FINAL PLANNED URBAN DEVELOPMENT REPORT & DECISION

Project Name: Whitman Court FPUD, Phase I

File Number: LUA14-001044, FPUD

Project Summary: The applicant is requesting a Final Planned Urban Development (FPUD) for the first of two phases of the Whitman Court PUD (LUA14-000295). The City's Hearing Examiner approved the Preliminary Planned Urban Development on June 11, 2014 subject to 40 conditions of approval. The first phase includes the construction of 20 (of the approved 40) zero lot line townhomes and the 2,657 square foot commercial bank on the 41st lot. The vacant 5.12 acre site is located within the Commercial Arterial (CA) zoning classification and the Commercial Corridor (CC) land use designation. The subject site is located on the southwest corner of the intersection of NE 4th St and Whitman Ct NE. Phase 1 would be comprised of 4 (of 8 total) multi-family residential structures resulting in a density of 11.4 du/ac and one commercial building. The commercial lot would be accessed from NE 4th St with remaining residential development gaining access from the existing portion, and proposed extension, of Whitman Ct NE. There is a Category 2 wetland located on the western por

BUILDING A ELEVATIONS
Date: 07/23/14
Drawn: TADG
Job #: 13002
Revision:

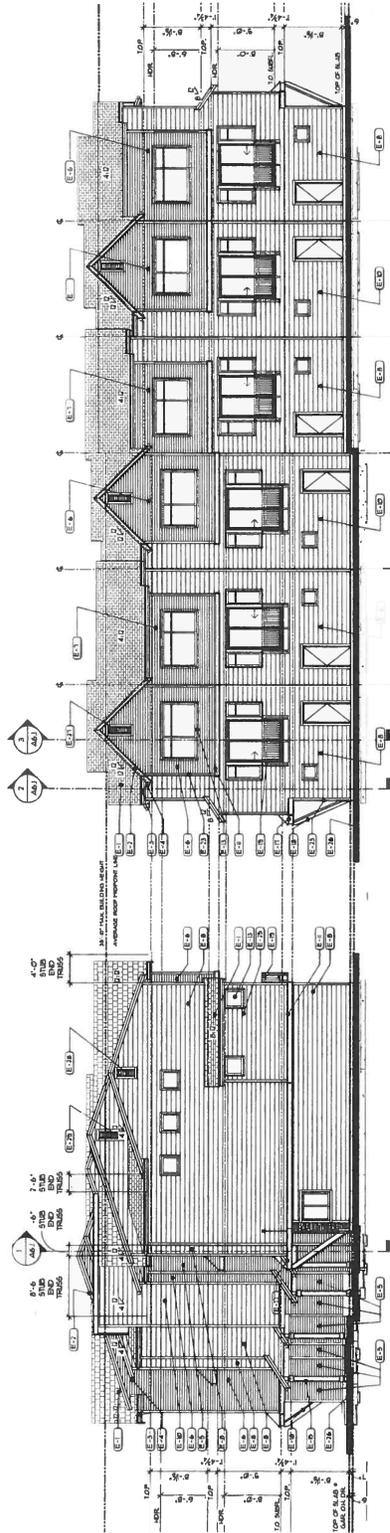
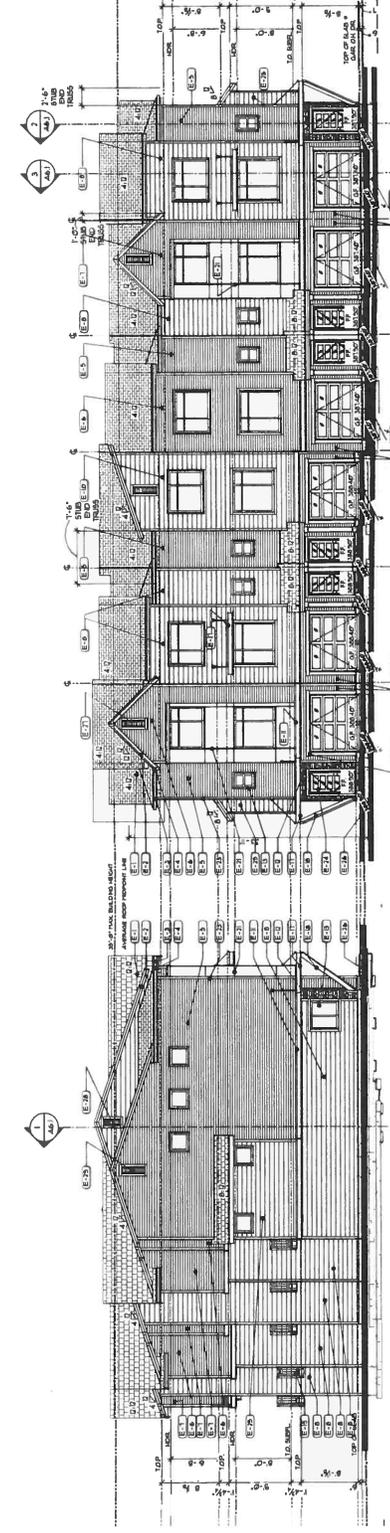
2).
<p>Compliant if condition of approval is met</p>	<p>25) <i>The applicant shall submit revised elevations depicting added architectural detailing elements including lighting fixtures, contrasting materials, or special detailing along the ground floor of all residential units and the northern and western façades of the commercial building. The revised elevations shall be submitted to, and approved by, the Current Planning Project Manager prior to Final PUD or building permit approval whichever comes first.</i></p> <p><u>Staff Comment:</u> The applicant submitted revised elevations as part of the FPUD application (Exhibits 5 and 6). Some of the conditioned detail elements are readily visible on the revised elevations however the applicant has noted additional elements could be presented at the time of building permit application. The revised elevations include contrasting materials (hardiboard beveled siding, wood braces, and entry stone) and modulation. Awnings and canopies have been included to provide special detailing along the ground floor for both the commercial and residential portions of the project.</p> <p>However, additional architectural elements are needed in order to meet the intent of this condition, and to ensure that buildings are visually interesting and reinforce the intended human-scale character of the pedestrian environment. In order to encourage building design that is more unique, urban in character, and is comfortable on a human scale, additional elements should be incorporated into the elevations. Staff recommends a condition of approval the applicant submit revised elevations which include additional architectural detailing to support a more distinctive design for the residential and commercial structures. The revised elevations shall be submitted to, and approved by, the Current Planning Project Manager prior to building permit approval. The applicant should consider the use of differing roof profiles, differing window sizes, lighting, additional braces, and/or additional changes in materials.</p>

<p>Compliant if condition of approval is met</p>	<p>26) <i>The applicant shall submit revised elevations depicting the use of the same materials finished on all sides of the building as well as additional changes in materials and color for the residential structures. The revised elevations shall be submitted to, and approved by, the Current Planning Project Manager prior to building permit/Final PUD approval whichever comes first. The applicant may also want to consider the use of the brick, integrally colored concrete masonry, or a similar high quality material, to ground the residential buildings for a height appropriate to the scale of the structure.</i></p> <p><u>Staff Comment:</u> Two separate material boards were submitted for the commercial and residential portions of the project. Based on the elevations and the provided color schemes, all buildings would be finished with a combination of entry stone, painted beveled hardiboard siding, and roof shingles. See additional comments and condition of approval associated with Condition #25.</p>

12. The applicant shall submit revised elevations which include additional architectural detailing to support a more distinctive design for the residential and commercial structures. The revised elevations shall be submitted to, and approved by, the Current Planning Project Manager prior to building permit approval. The applicant should consider the use of differing roof profiles, differing window sizes, lighting, additional braces, and/or additional changes in materials.

13. The applicant shall be required to submit revised elevations depicting additional ornamental lighting fixtures. The revised elevations shall be submitted to, and approved by, the Current Planning Project Manager prior to building permit approval.

3. The applicant shall submit revised elevations with additional architectural detailing on all sides of the residential buildings facing a street. The revised elevations shall be submitted to, and approved by, the Current Planning Project Manager, prior to the commercial building permit approval.

Sheet Title: EXTERIOR ELEVATIONS & DETAILS

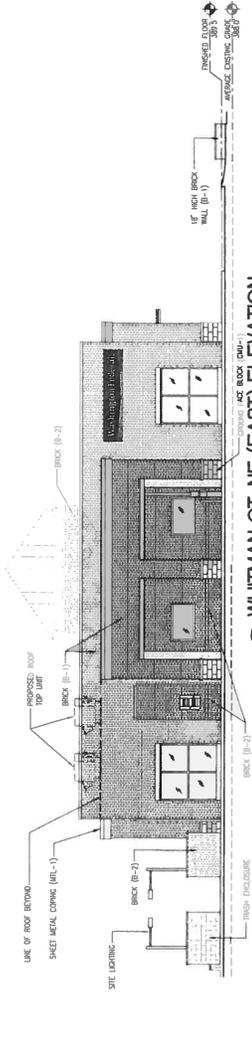
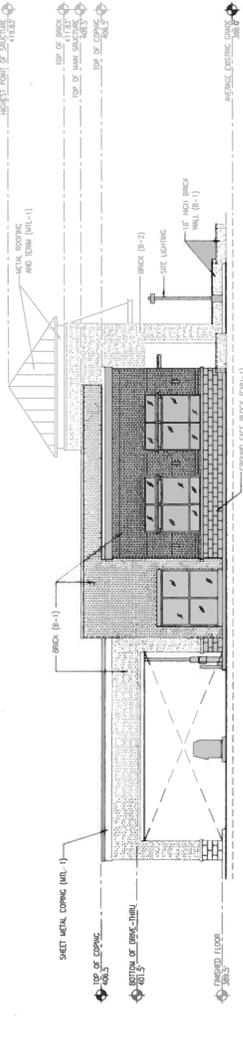
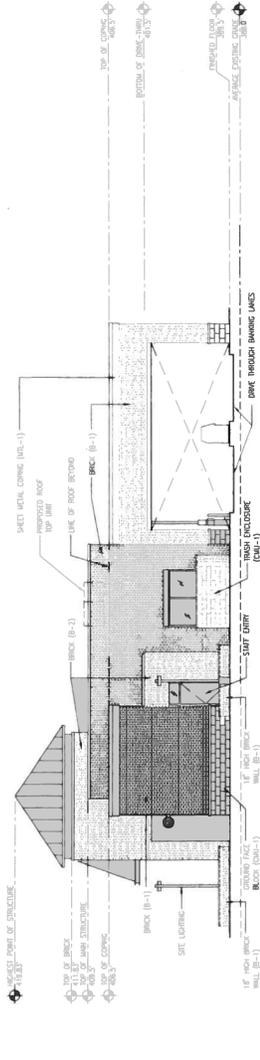
Deferred to Building Permit Approval	<p>21) <i>The applicant shall be required to submit revised elevations which include the refuse and recyclable enclosure made of masonry, ornamental metal or wood, or some combination of the three, and a roof. The revised elevations shall be submitted to and approved by the Current Planning Project Manager prior to building permit approval.</i></p> <p><u>Staff Comment:</u> The applicant has indicated that the refuse and recyclable enclosure for the proposed bank is made of masonry, ornamental metal or wood, or some combination of the three, and has a roof. This condition will be verified at the time of commercial building permit approval.</p>
✓	<p>22) <i>The refuse and recycling facilities shall be screened with landscaping on a minimum of three sides. The revised landscape plan shall be submitted to, and approved by, the Current Planning Project Manager prior to construction permit/Final PUD approval whichever comes first.</i></p> <p><u>Staff Comment:</u> The provided landscape plan, approved on October 20, 2014, includes landscape screening for the refuse and recycling facilities on a minimum of three sides to the satisfaction of the Current Planning Project Manager (Exhibit 3).</p>

11. The applicant shall be required to submit revised elevations which include the refuse and recyclable enclosure made of masonry, ornamental metal or wood, or some combination of the three, and a roof. The revised elevations shall be submitted to, and approved by, the Current Planning Project Manager prior to building permit approval.
